1 INTRODUCTION

- 1.1 Tetra Tech (TT) were appointed in 2022 by Hodgetts Estates Limited to provide technical transport and highways support for their outline planning application (PAP/2021/0663) for a proposed development of up to 100,000sqm of employment floorspace and a 150-space overnight lorry park (including an associated 400sqm amenity block) on land north-east of M42 Junction 10. The application is also supported by a Transport Assessment (TA) prepared by TT, dated February 2023.

NH RESPONSE of 21st SEPTEMBER 2023

Review of Modelling Relating to the Development at Land to Northeast of M42 Junction 10

Image 2.1: A5/ Core 42 – Observed Stages

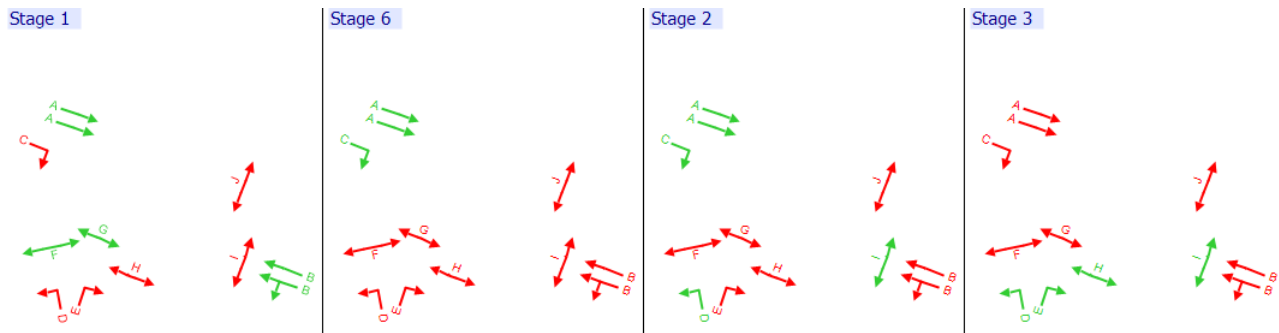
It has been difficult to see how the signal timings for this junction have been determined from the signal data provided. we recommend the applicant set out how the stage lengths have been determined and how the frequency of the demand dependent stage has been determined, both linking back to the signal data provided.

Rather than use the "Run every N cycles" feature, it may be more appropriate to use the "Probability of running (%)" feature instead if the number of occurrences the stage gets called is not a whole number.

Please also review the signal data to confirm what happens to the timings when the intermittent stage is not called. The TRANSYT model is currently set up exclude skipped time (i.e. the cycle time shortens). If the junction is under MOVA control, the cycle time

will vary, so it is probably likely that the time will be skipped and the cycle time will be shortened. However, it may be worth confirming that the green time isn't reallocated to adjacent stages. Please refer to section 24.8 of the latest TRANSYT 16 user guide for more information.

The signal data supplied by the applicant suggests that in both peaks Stage 2 is not called every cycle, so should this also be an intermittent stage? Approach 3g (Phase C) in Stage 2 is not called as often as Approach 3a and 3b (Phase B) in Stage 1. Also, some green durations of Phase B are greater than the average cycle time, suggesting that it runs for more than one cycle when the other two stages aren't demanded during a specific cycle. National Highways welcomes the opportunity to review and comment on the following models & files associated with the application:

A5/ Core 42 (Controller 8)

2.14 The operation of the A5/ Core 42 is demand dependent and responds promptly to vehicles queuing at the stop lines. In the AM peak the number of vehicles turning left and right out of the site is quite low and so these stages are infrequently called. Following a review of the survey videos it is apparent that the on-street staging is slightly different to that in the signal's specification. There is a stage which only runs Phase A and C together (A5 eastbound ahead and right turn), same as Stage 2 except it does not include Phase D (left turn out of Meridian Drive) as there is no vehicle waiting at the stop line triggering the green signal to be activated. This stage has been replicated in the model and called Stage 6, see Image 2.1 below showing the observed stages.

- 2.15 In the AM peak the observed signal timings show that Phase A runs with long green periods (during Stages 1, 6 and 2) and only receives a red signal during Stage 3, i.e. when Phase E is called (right turn out of Meridian Drive). Phase B (A5 westbound) receives a green signal for 54 secs during a typical cycle and is called 47 times in the hour. Phase C is called 40 times (85% of cycles) in the hour and typically runs for 8 secs each time. Phase D is called 20 times (45% of cycles) in the hour and typically runs for 10 secs. Finally Phase E is only called 5 times (10% of cycles) in the hour and for 7 secs on average.

- 2.16 The “probability of running %” feature had been used for Stages 2 and 6, with Stage 2 (Phases A, C & D) being set to 40% and Stage 6 (Phases A & C) being set to 50%. As Phase C runs in both stages it will be called 90% of the cycles, similar to that observed on average. Phase D within Stage 2 will be called typically every 2nd cycle, also similar to that observed on average.

- 2.17 By applying this method to Stage 3 (Phase E), as it is called so infrequently, there are instances (when reviewing the signals log in the model) that the stage is called in back-to-back cycles and then not called for another circa 15 to 20 cycles, thus resulting in very long delays at this stop line which is not representative of the observed conditions. As TRANSYT cannot be configured to model demand dependent stages (triggered when a vehicle arrives at the stop line) it is considered more reasonable to use the “run every N cycles” option for this Phase, thus ensuring it is called 5 times in the hour (every 8th cycle) and resulting in delays which are more representative on this lightly trafficked approach.

- 2.18 By setting the AM peak cycle time to 90 secs it enables the resultant green periods in the model to be representative of those observed as discussed above. The modelled queues are very similar to those observed, see Table 4.1v2 in Appendix C discussed at Chapter 3 below.

The changes made to the AM peak timings at this junction are therefore considered acceptable.

FIGURES

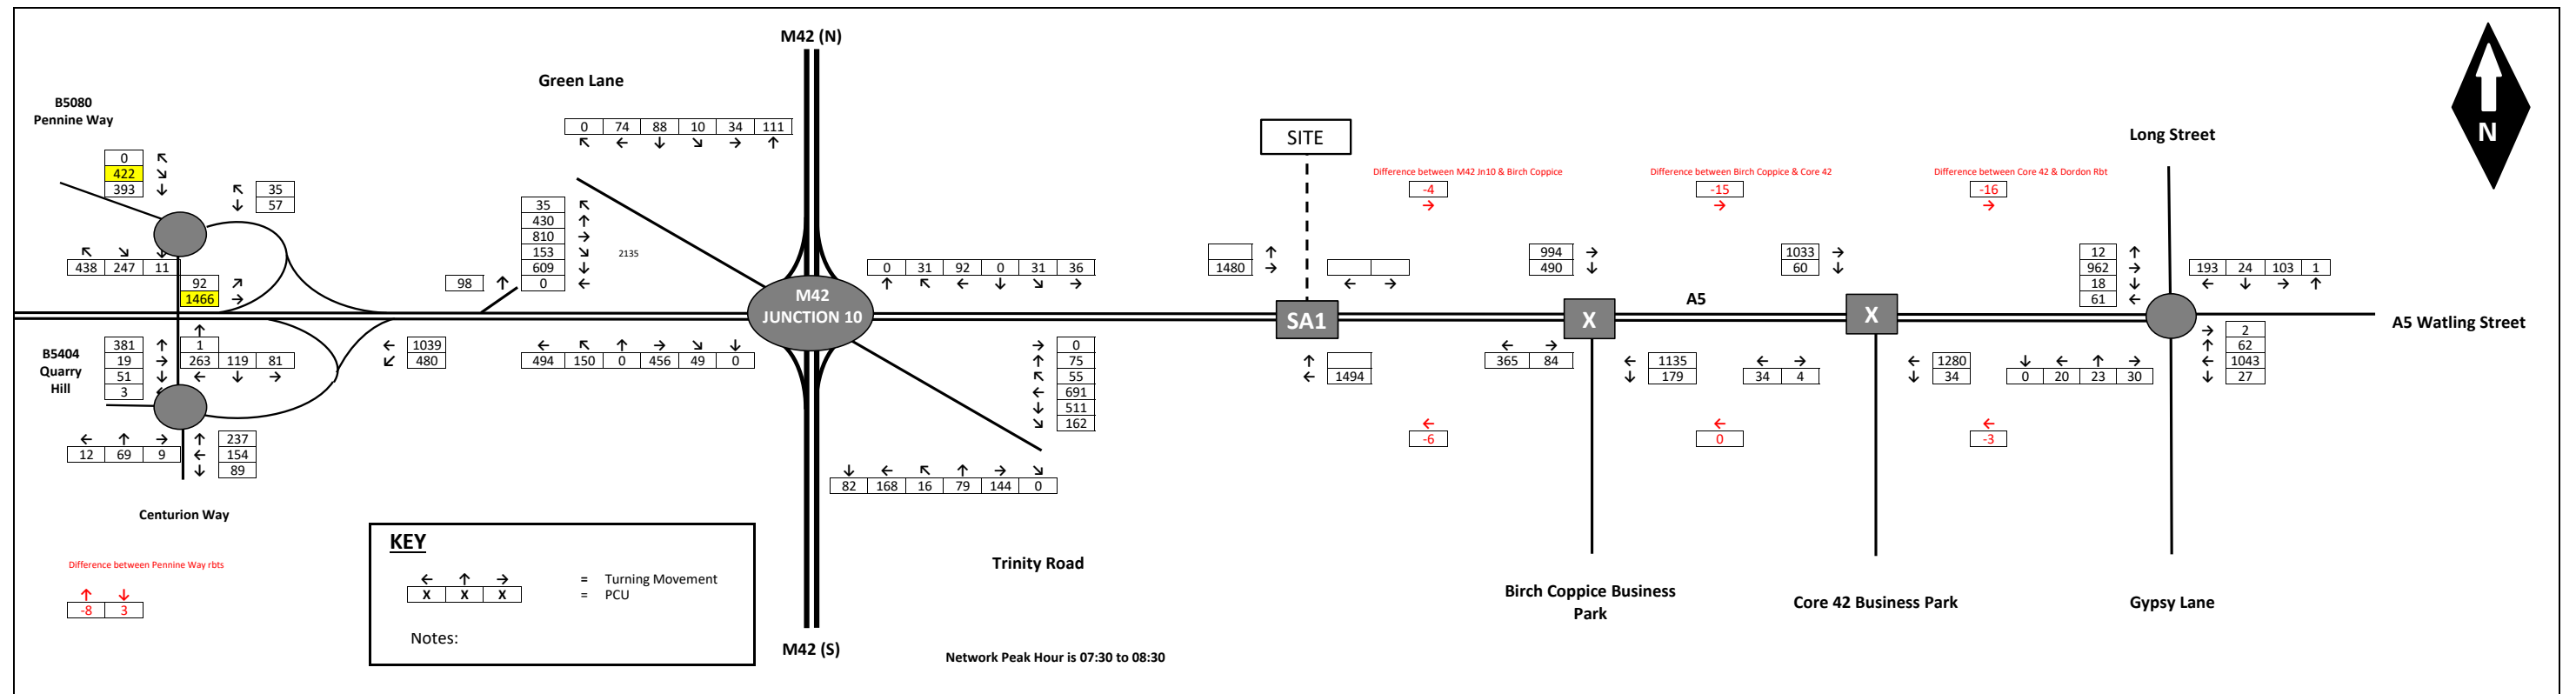
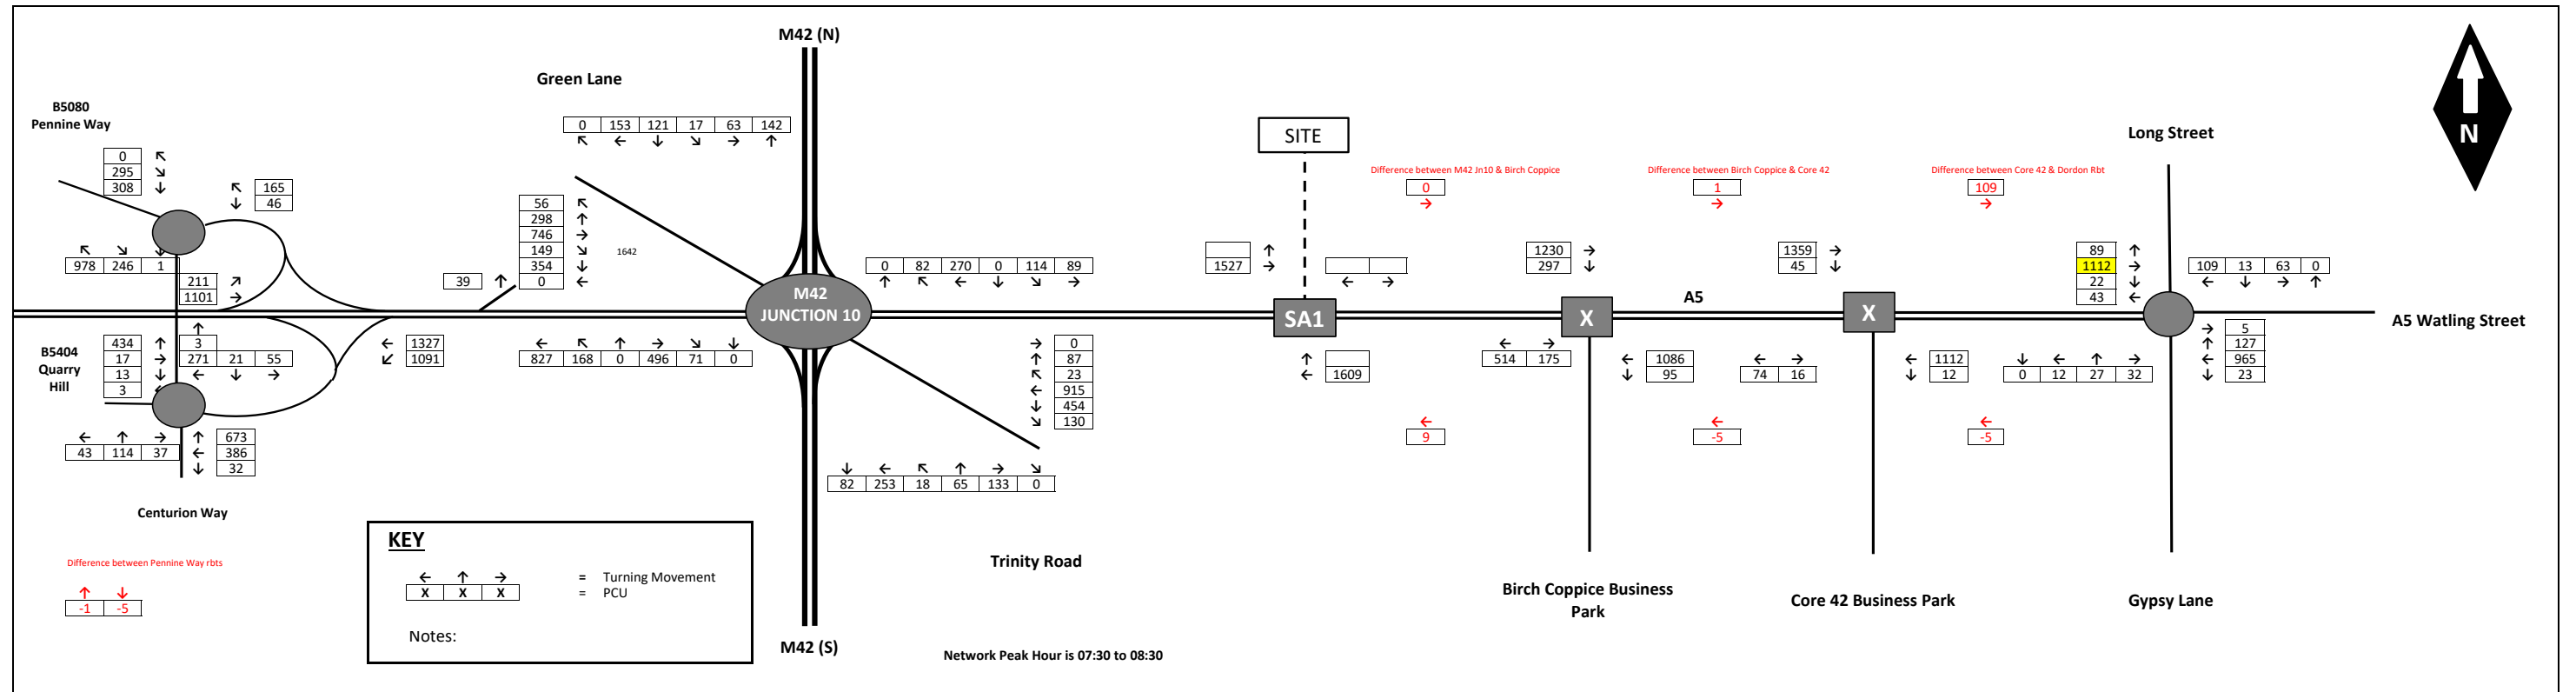
We note the following flow inconsistencies when comparing the flow spreadsheet (MHC-110-23 Classified Junction Count – All Sites.xlsx) and the TRANSYT model supplied:

- At node 2 (A5 / Danny Morson Way), the A5 Westbound left turn into Danny Morson Way has been modelled as 147 PCUs in the AM Peak, but is 179 PCUs in the traffic survey. In the PM Peak on the same movement, 147 PCUs has been modelled, but the spreadsheet shows a flow value of 95 PCUs.
- At node 4 (B5080 Pennine Way Northern Roundabout), the AM Peak flows on the Pennine Way northern arm (Arm 54) do not correspond to the flow spreadsheet. The flow to the overbridge is 422 PCUs in the model and 393 PCUs

in the spreadsheet, whilst the flow to the A5 slip road is 417 PCUs in the model and 422 PCUs in the spreadsheet.

- At node 7 (A5 Dordon Roundabout), the A5 Eastbound ahead flow in the PM Peak has been modelled as 1,212 PCUs, but the flow spreadsheet shows a flow of 1,112 PCUs. This could perhaps explain why the applicant has had to increase the intercept value on this approach (Paragraph 4.10 of the report). Please review the flow, as well as the give way parameters to ensure the model accurately represents the observed situation.

We therefore request the applicant to update the flow matrices to match the flow spreadsheet information that has been supplied.

- 2.1 NH state that flow discrepancies of under 10pcu could be considered insignificant if there are no obvious “sinks” in the network, particularly to the west of Junction 10. Upon review of the 2023 AM peak, the total flow departing from Junction 10 (Local Matrix 1) and heading west on the A5 (to Local Matrix 5) is 1519pcu. The total flow departing from the A5 west at Local Matrix 5 (the A5 mainline/ Pennine Way slip roads) is 1519pcu, which is the same. In the reverse direction the total flow heading east from Local Matrix 5 is 2127pcu. The total A5 west flow arriving at Local Matrix 1 is 2135pcu, thus an 8pcu difference. This slight discrepancy has been corrected so that the total flow leaving Local Matrix 5 on this movement is consistent with that arriving Local Matrix 1, refer to Figure 1v2 attached in Appendix B. The traffic flows in the model have been updated accordingly.

2.4 At Local Matrix 4 (Pennine Way Northern Roundabout) the modelled flow has been corrected for the AM peak hours as identified by NH and a revised Figure 1v2 is attached at Appendix B. The TRANSYT model has been updated accordingly.

2.5 At Local Matrix 7 (A5/ Dordon roundabout), as discussed at para 3.5 in the Validation Report, there was a difference between the A5 eastbound exit flow at the A5/ Core 42 junction and the A5 eastbound entry flow at Dordon Roundabout of 109pcu. At that time it was considered appropriate to apply a 100pcu uplift onto the ahead movement as that would result in a higher flow at the roundabout entry. However, noting NH's comments and on the A5 between the A5/ Core 42 junction and Dordon Roundabout there are a number of minor access roads, such as New Street, it is likely that the flow discrepancy results from vehicles leaving the A5 to these accesses. As a result, the A5 eastbound approach flow to Dordon Roundabout has been returned to the survey value of 1112pcu to match the observed turning counts. Traffic flow diagram Figure 3v2 attached in Appendix B refers and the model has been updated accordingly.
